City of San Antonio

Re: Steubing Babcock Road

MDP # 021-06

The City Staff Development Review Committee has reviewed Steubing Babcock Road Master Development Plan **MDP # 021-06**. Please find enclosed a signed copy for your files. Your plan was accepted, however, please note the following conditions:

MDP 06-021 (250.4 acres)

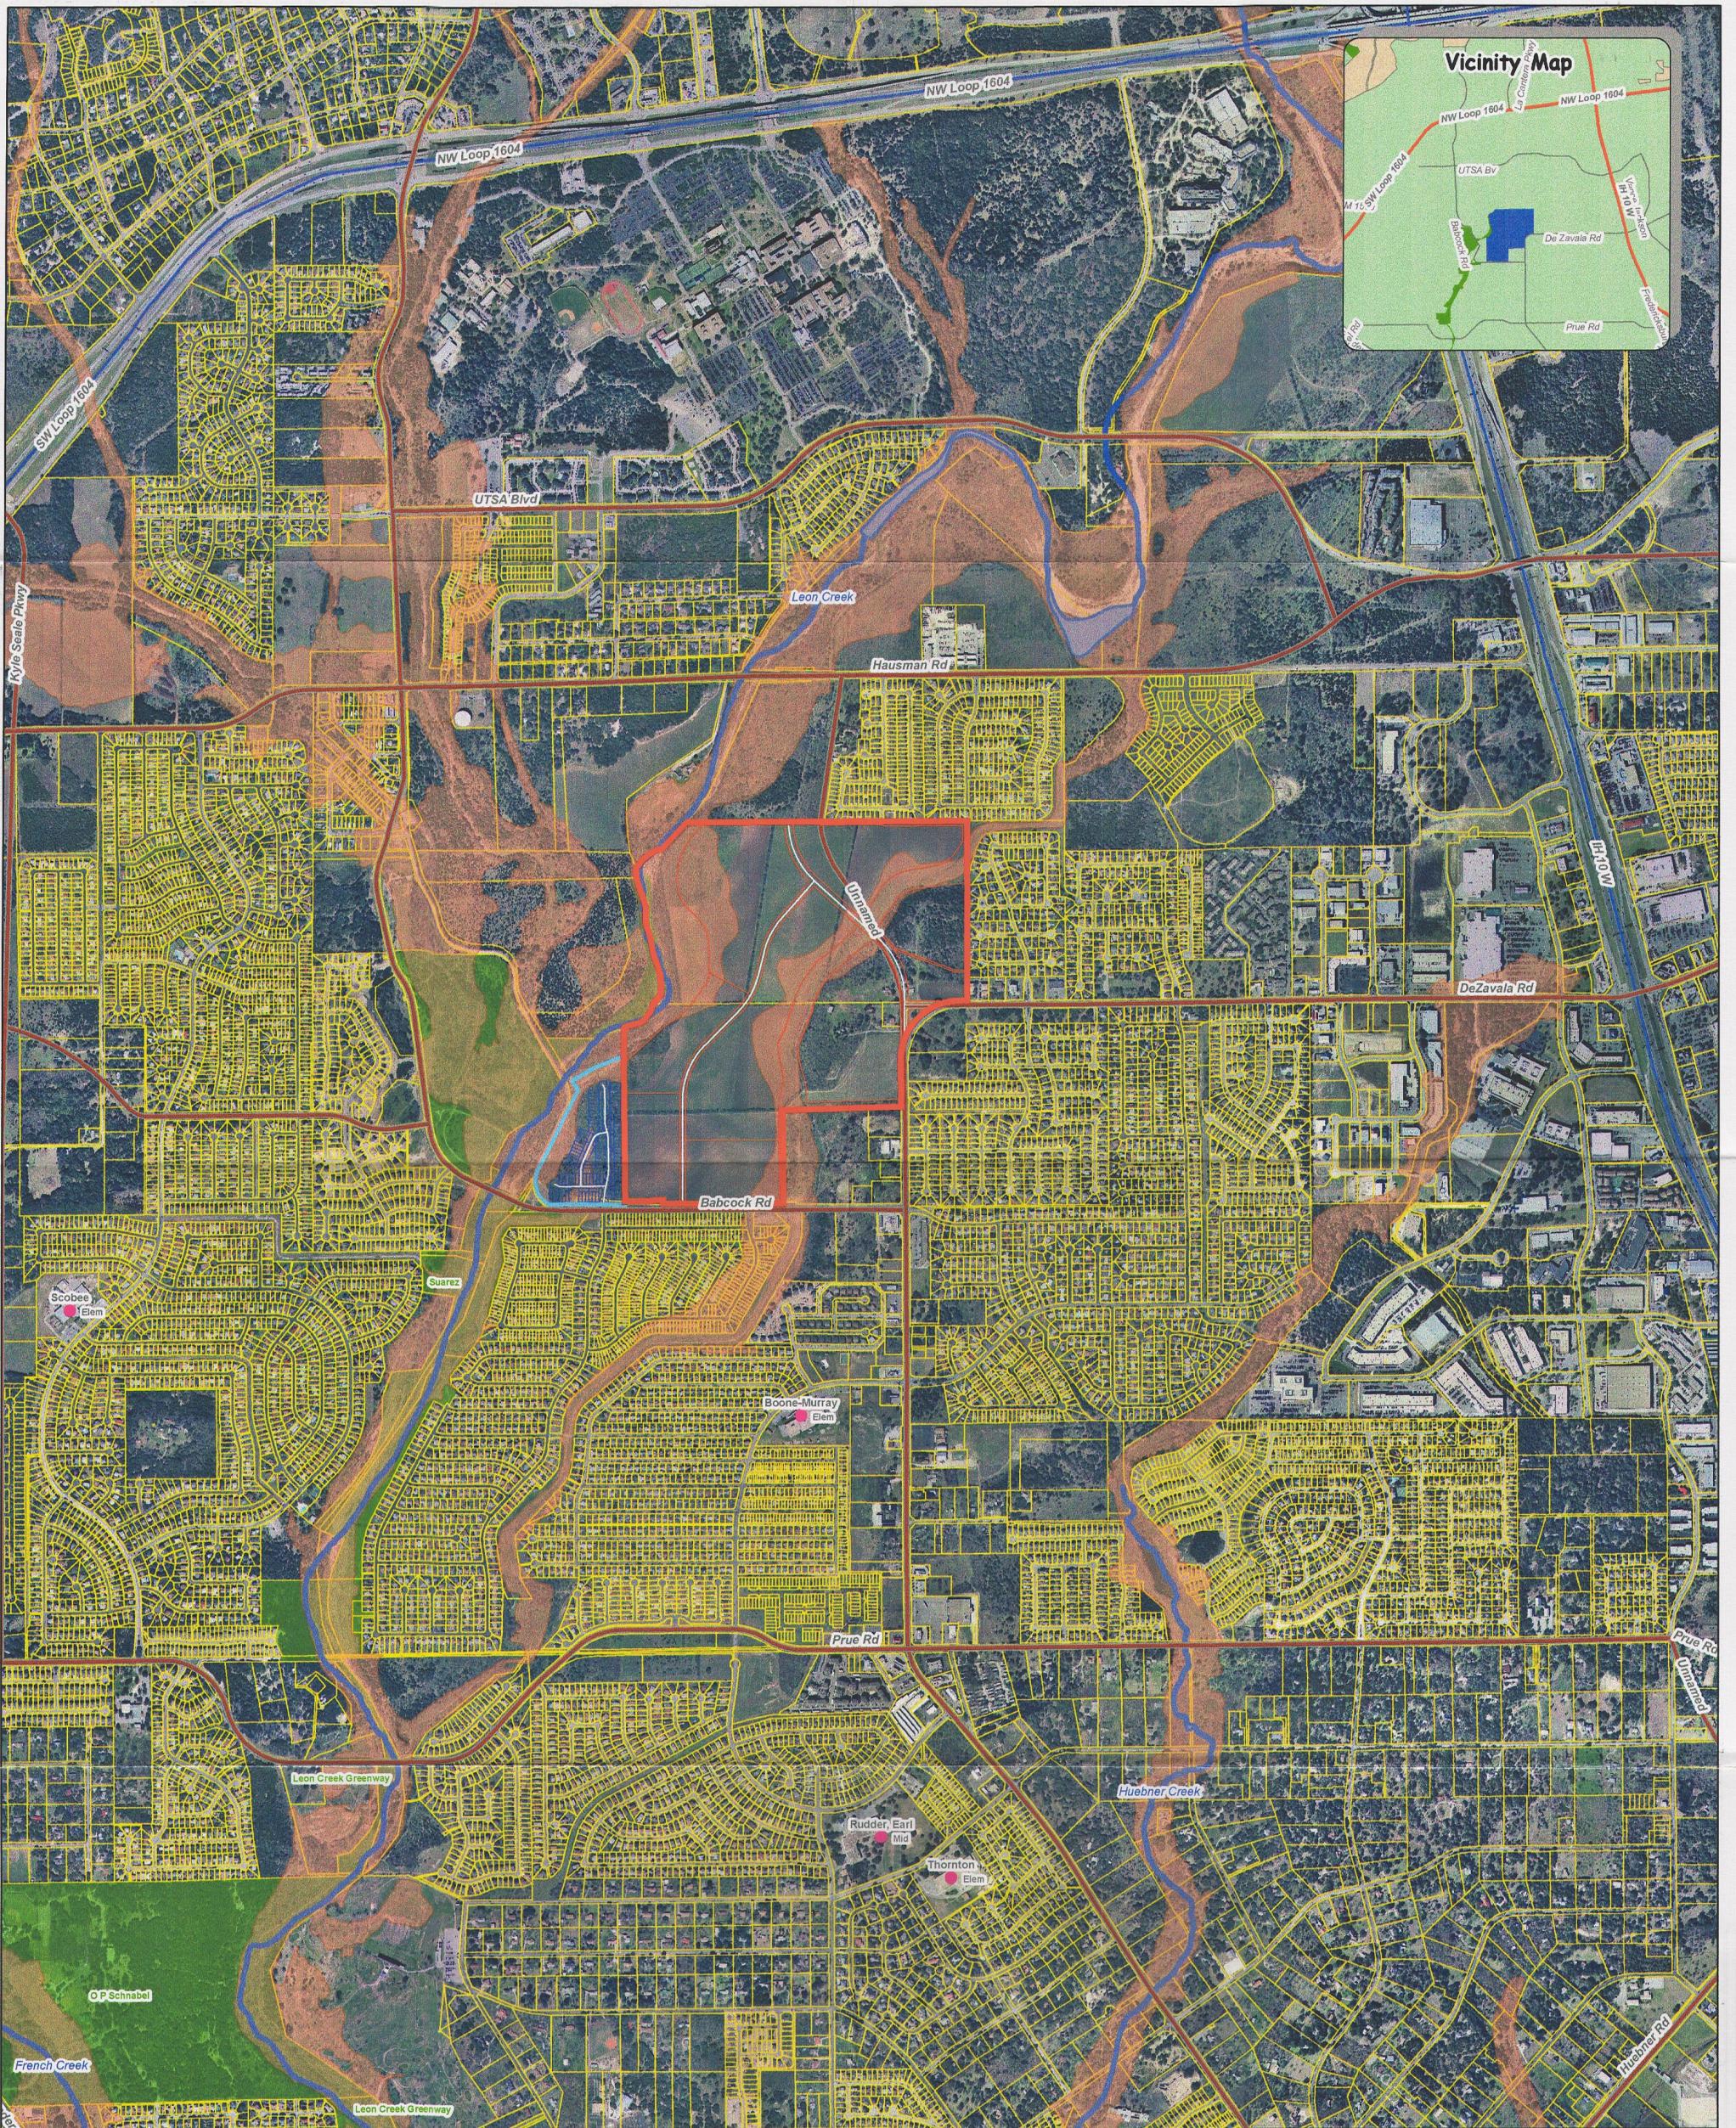
In consideration of public safety and convenience, excessive grades by reason of topography should be avoided in street layouts and arrangements. Any access and right-of-way issues along state facilities will need to be resolved with the **Texas Department of Transportation (TXDOT)**. For information about these requirements you can contact TXDOT at 615-5814.

- All access roadways shall provide clear sight distance on all existing and proposed roadways in order to provide adequate obstruction free viewing distances for approaching traffic. All signage, landscaping, and improvements shall be selected and located so as to not to block these clear sight distance areas.
- All access driveways for this project shall comply with UDC 35-506(r) Access and driveways in terms of number of driveways, spacing, location, and design.
- Sidewalks along all interior and exterior roadways are to be installed in accordance with UDC 35-506(q).
- Right turn deceleration lanes shall be required in the following locations:
Westbound W. De Zavala Road at street A.
Southbound S. Babcock Road at street A.
- Separate left-turn lane lanes shall be required at the following locations:
Eastbound W. De Zavala Road at street A.
Northbound S. Babcock Road at street A.

- Right and left turn lanes should be designed according to City of San Antonio guidelines.
- Incorporated traffic control improvements such as signing and pavement markings into the site plan that conform to the Texas Manual on Uniform Traffic Control Devices for consistent uniform traffic control.
- Design and construction of a traffic signal shall be required when warranted at the following locations S. Babcock Road and E. De Zavala Road, street A and S. Babcock Road, and Street A and W. De Zavala Road of this development and shall be coordinated with City of San Antonio Public Works Traffic, and DSD TIA reviews for approval.

- The parkland provided shall be shown as “Park” or “Open Space” on a plat; UDC section 35-503(e) *Designation of Parkland*.
- The parkland provided shall be dedicated to the Home Owners Association.
- The instruments creating the Home Owners Association shall be provided by the second application for plat approval; UDC section 35-503(e) *Designation of Parkland*.
- Parkland dedication shall be platted by the second phase of residential development; UDC section 35-503(f) *Development Phasing*.
- All amenities comply with standards and specifications found in UDC section 35-503(h) *Credit for Park Facilities* and Table 503-4 if any credit is to be awarded.

- 2003 Tree Preservation ordinance standards per UDC Section 35-523 – a Tree Preservation Plan is required prior to any work on site. This can be submitted either as a site work permit or at the platting stage.
- Streetscape standards per UDC section 35-512 – The new right-of-way (collectors) will require streetscaping (we recommend preservation of existing trees where available and possible).
- Landscape ordinance per UDC section 35-511 on commercial and multi-family phases. It appears all landscape points can be met by preserving existing vegetation in some phases as well as meeting mitigation requirements (either through preservation of smaller material or transplanting). Recommend securing knowledgeable Landscape Architect at planning and design phase to better utilize existing trees and vegetation. Preservation will

- 100 year Flood Plain Shown and Buffering (if applicable).
- Significant Recharge Features and Buffering (if applicable).
- Category Letter for All Site Specific Plats (if Category 2 or 3, an Aquifer Protection Plan is required).
- Additionally, a Water Pollution Abatement Plan or Contributing Zone Plan must be submitted to and approved by the Texas Commission on Environmental Quality (TCEQ) prior to construction.
- According to the Water Quality Ordinance# 81491, section 34-913, Buffering may be required.

Historic Preservation: The Texas Sites Atlas indicates that archaeological sites have been previously identified within the above referenced property. Also, the property may contain other sites, some of which may be significant. Thus, before any work that may affect any sites is begun, we recommend that qualified professionals conduct an archaeological and historical structures investigation of the property. The investigations should be performed according to Archeological Survey Standards for Texas, and previously identified sites should be reexamined and reevaluated, if any.

All platting shall comply with the Unified Development Code, Master Plan, and Major Thoroughfare Plan for the City of San Antonio. It will be expected that you will plat all of the property depicted in your Master Development Plan to include floodplains, drainage areas, and open space. It is suggested to work closely with the school district, so they can plan accordingly.
